MCNARY PIT DESIGN CONCEPTS

FFDRWG
7 November 2024

MCN PIT DETECTION PROJECT DELIVERY TEAM

#7 EMBED IN OGEE WITH RESHAPING

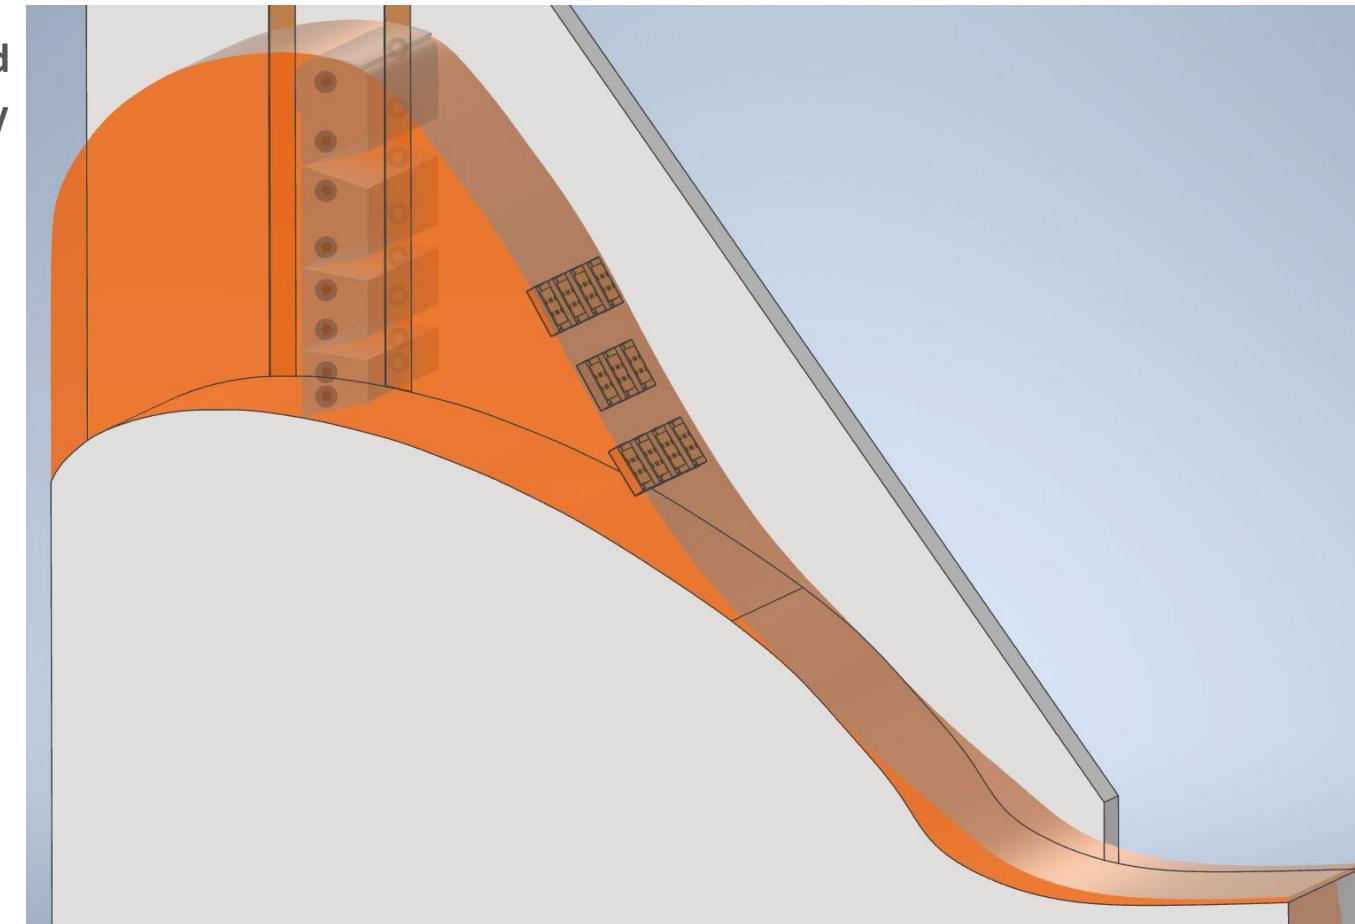
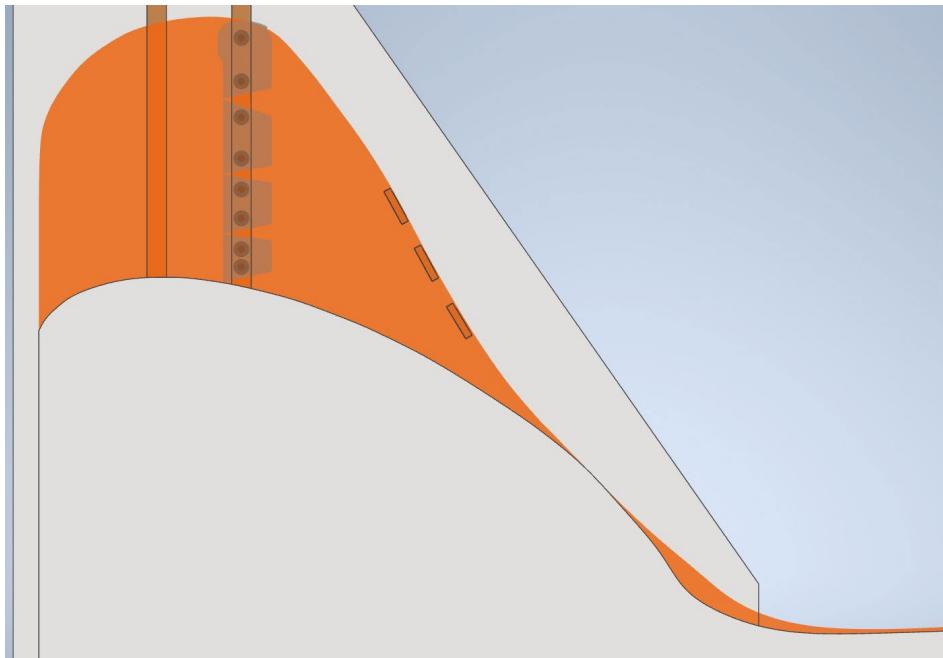
- a. Higher cost
- b. Permanent once installed
- c. **REMOVED FROM CONSIDERATION**- probable max flood
- d. Look at maintenance data at LGR and see if there is any indicator for maintenance issues or problems

#8 PIT BARGE IN FOREBAY OR TAILRACE

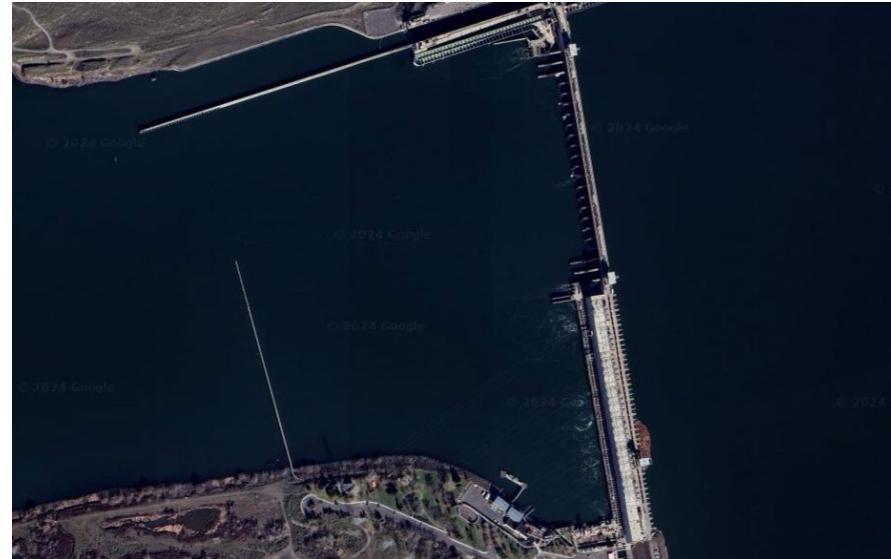
- a. Con- need it to be placed in location where most fish are (upstream would be in shipping channel)
- b. Immediately upstream of spillway would raise dam safety concerns
- c. Would require an entire staff to manage and maintain- expensive
- d. April-may peak run time for fish but would need to extend through summer to capture all fish
- e. Lots of vibration, especially in tailrace
- f. **REMOVED FROM CONSIDERATION**

#9 JBS OUTFALL ANTENNA

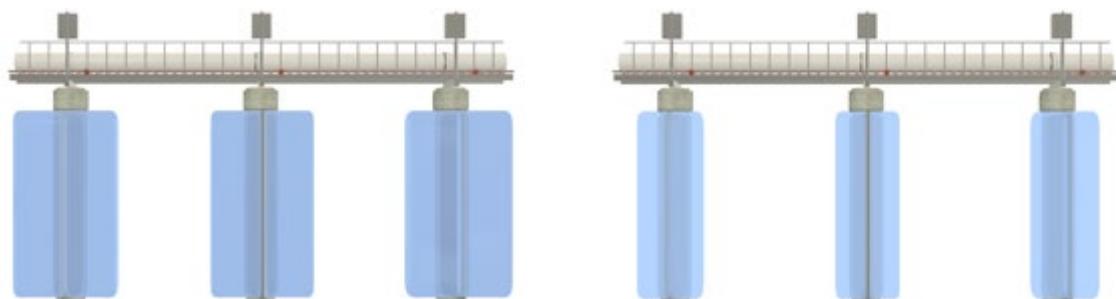
- a. Pro- This is scalable.
- b. **REMOVED FROM CONSIDERATION** -high water goes over the top of the outfall pipe and has taken out the water gun on multiple occasions and parts of the catwalk. High probability of losing any infrastructure placed on outfall piers from debris
- c. Last pier is 120 ft depth
- d. Lots of space between piers so would need to know what detection we would get
- e. Power would be on shore
